MOORE PUBLIC SCHOOLS -SOUTH LAKE ELEMENTARY SCHOOL 2022 CLASSROOM ADDITION

ADDENDUM NO. 1

June 1, 2022

ENGINEER'S RFI RESPONSE RFI NO:

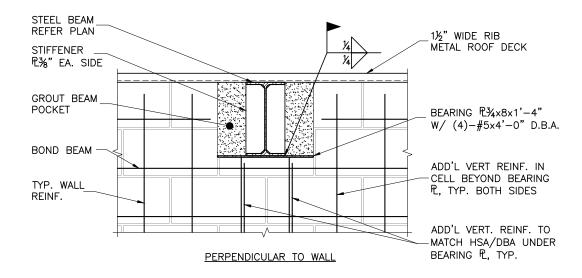
1. Sheet S104, Detail #13, Embed Plate Detail: refer to attached revised detail.

Use the same embed plate as 13/S104 at each beam bearing location.

13 BASE CABINET W/ DOORS

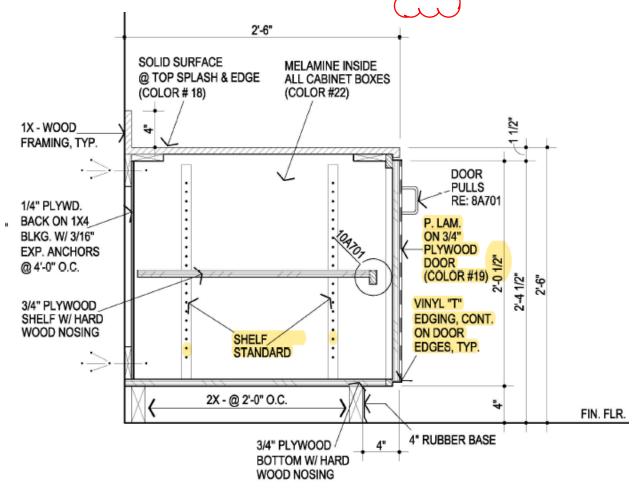
The drawing shown below from page A701 shows the following:

- 1. P.Lam on 3/4 Plywood. The specs page 06410-4 line A. Core, under 2.02 Materials ..Particle Board... May we use the spec written in the specs?
- 2. 3/4 Plywood shelf w/hardwood nosing. 06410-4 line D. Edging under 2.02 Materials ...1. 1mm, 2. 3mm PVC edge banding... May we us the written spec?
- 3. Vinyl T edging on door edges. May we user the same spec as stated in the previous question?
- 4. Shelf Standard. 06410-6 line 5. under 2.05 Fabrication Side Panels...adjustable shelf hardware at 32mm line boring. May we use the written spec

Date	May 23 rd , 2022	
Project	South Lake Elementary Classroom Addition	
Subcontractor / Supplier		
7 Опрысі	Address:	
Manufacturer		
Spec. Section	RFI 1 Millwork	
Notes Below		
Clay / Mike please see the RFI request below.		
Thanks		
Please see attached for millwork questions.		
REFER TO ANSWERS BELOW.		
M.A.
